Service Bulletin

Bulletin No. 2004-06R1

Remote Control Requirement for 2005 Model Year 8/9.9 HP FourStroke Outboards

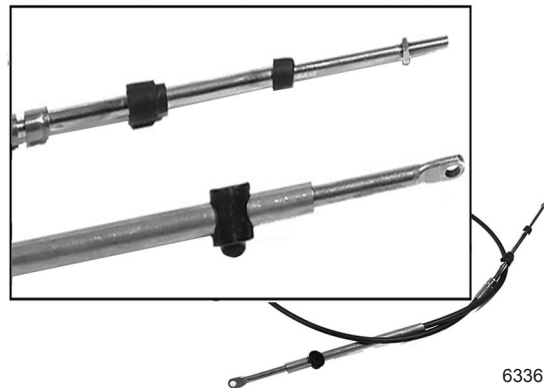
2. Select the correct length throttle/shift cables [64-809894__ (cable lengths 5 - 40 ft.)]

NOTE: These cables must be used with this control. They have GEN I control ends and SAE engine ends.

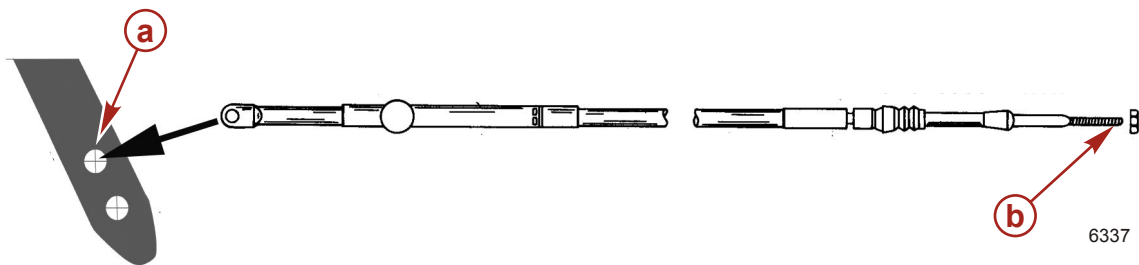
3. Install the control end into the side mount control in accordance with the special instructions shown. The upper control end attaching hole on a standard gearcase is required.

a - Control end attaching hole

b - Engine end
